AGENDA
Special Meeting
VILLAGE OF PLEASANT PRAIRIE
PLEASANT PRAIRIE VILLAGE BOARD
Village Hall Auditorium
9915 – 39th Avenue
Pleasant Prairie, WI
January 30, 2012
Immediately following the 6 p.m.
Plan Commission Meeting

VILLAGE STAFF REPORT OF JANUARY 30, 2012

Consider the request of Jonah Hetland, agent for BFU II LLC, owner of the property located at the southeast corner of 91st Street and 22nd Avenue for approval of a **Conceptual Plan** for a 46-unit affordable, independent senior-only apartment complex.

CONCEPTUAL PLAN FOR PROPOSED SENIOR HOUSING PROJECT: At this time, the Developer is proposing to develop a two (2) story building with 46-units of affordable, independent senior apartments on the 3.2 acre property located at the southeast corner of 91st Street and 22nd Avenue.

SCALE 1" = 20'

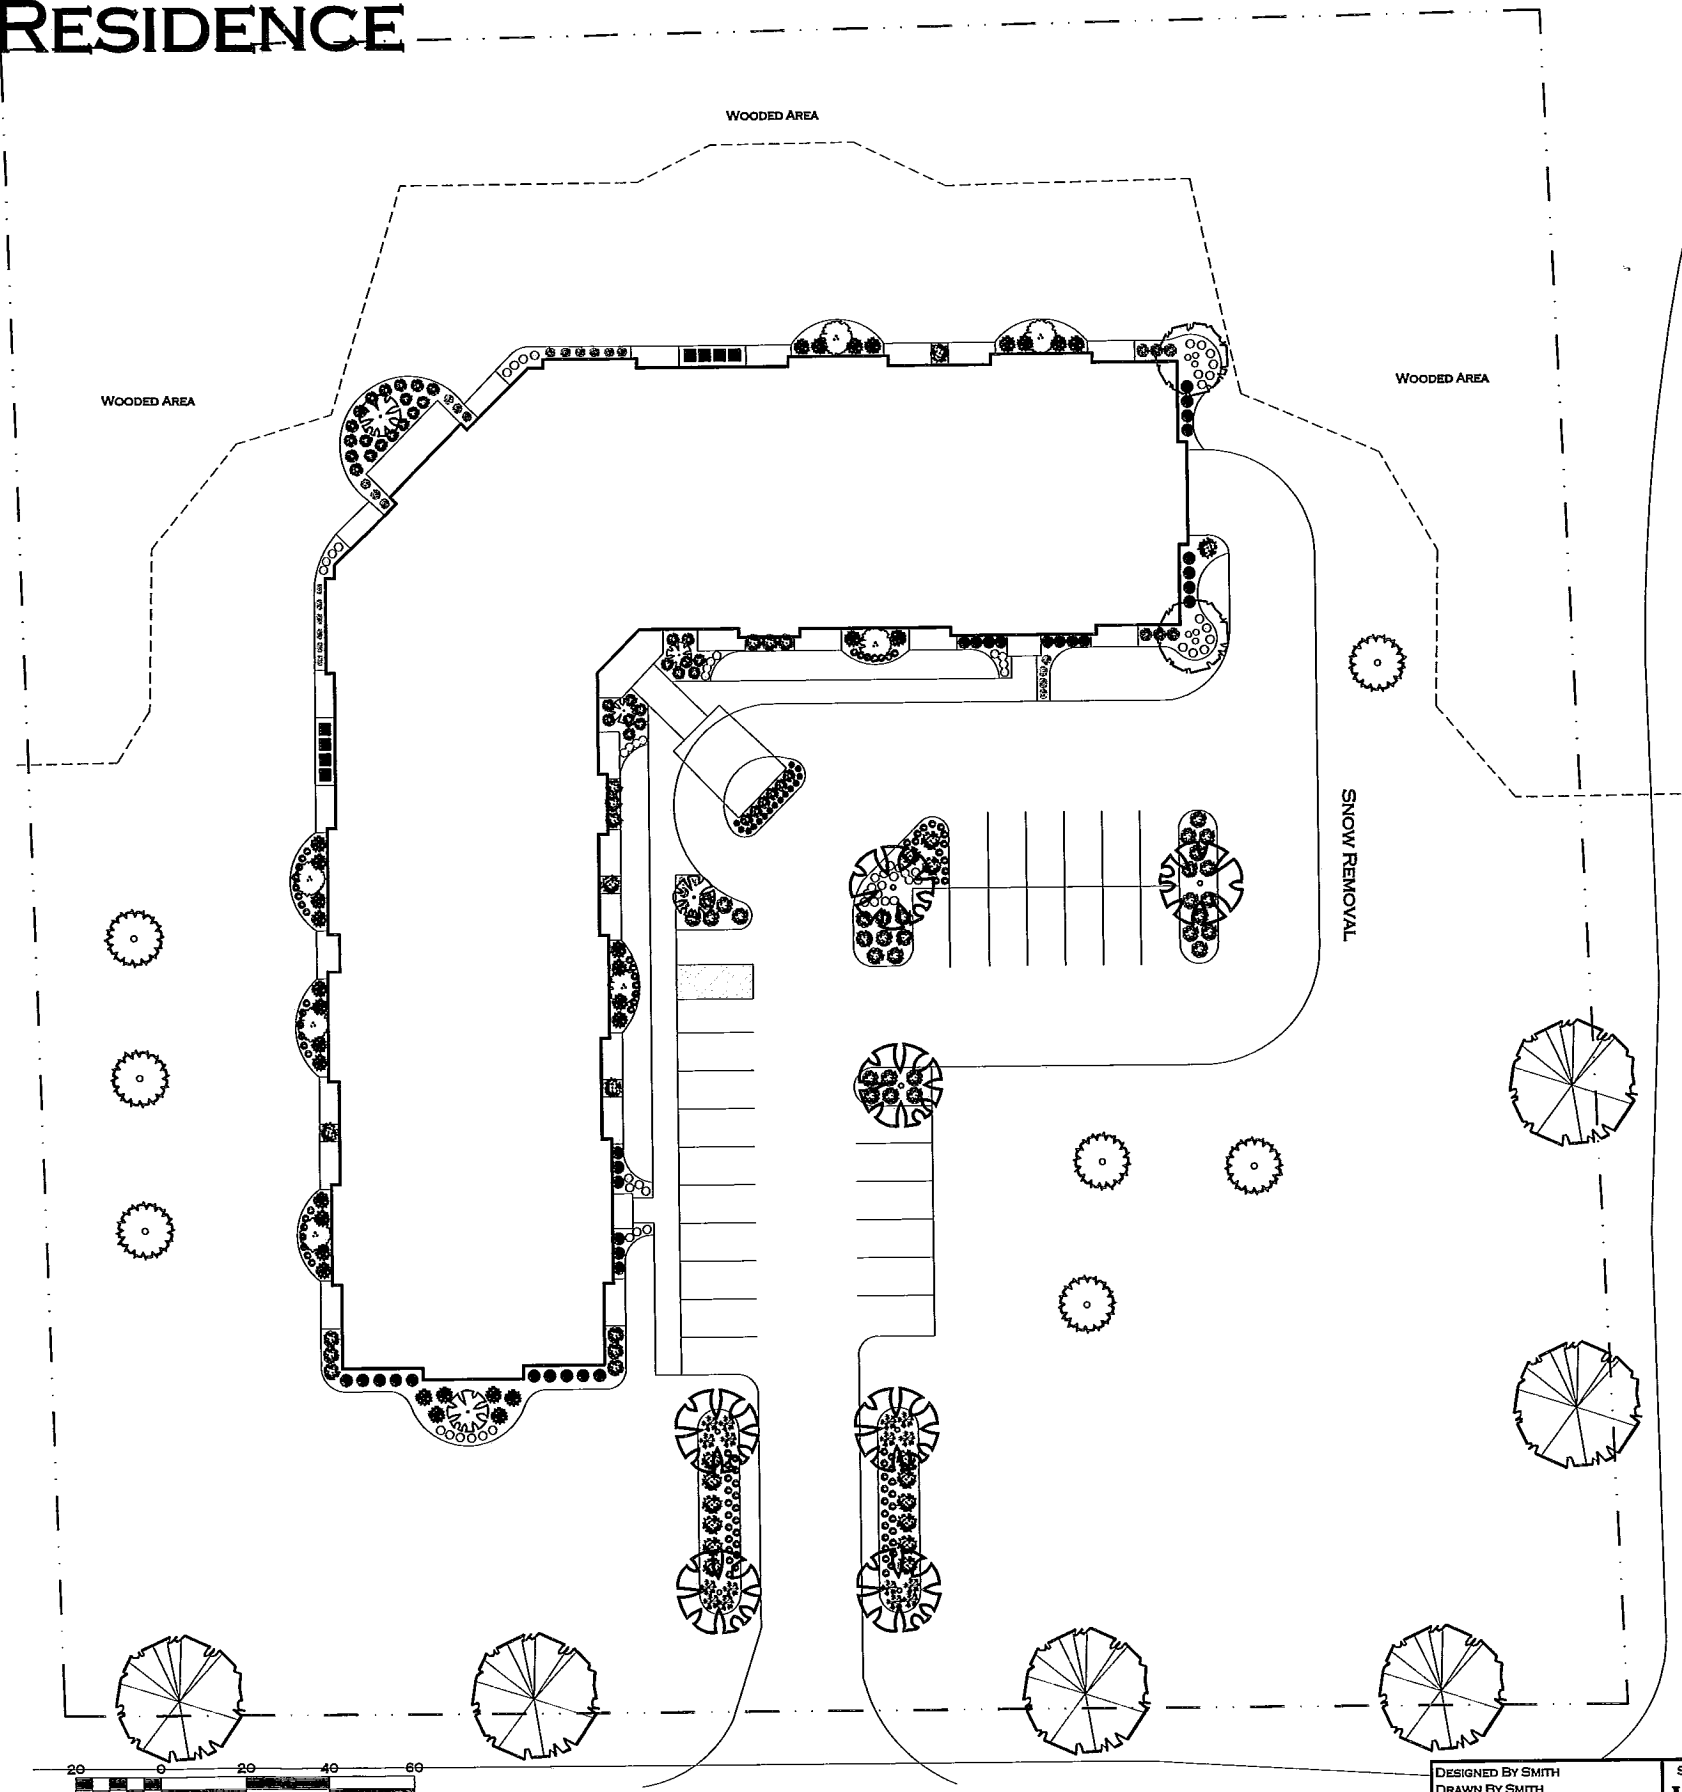
- i. The base map for the Landscape Plans shall be the approved grading plan.
 - ii. Landscape screening to block headlights shall be planted adjacent to the parking areas abutting 22nd Avenue and the east property line.

- iii. An irrigation system for the foundation plantings is required and shall be shown on the plans.
 - iv. The location of all pedestals and transformers and proposed screening.

- v. Street trees shall be planted every 50 feet along 22nd Avenue and 91st Street.
 - vi. Detailed information on how the plants will be staked or secured and placed in mulch areas shall be detailed on the landscaping plans.

- vii. Plantings shall be added to screen/protect the intersection corners from the retention basin.
 - viii. Additional comments forthcoming from the Village Public Works Department.
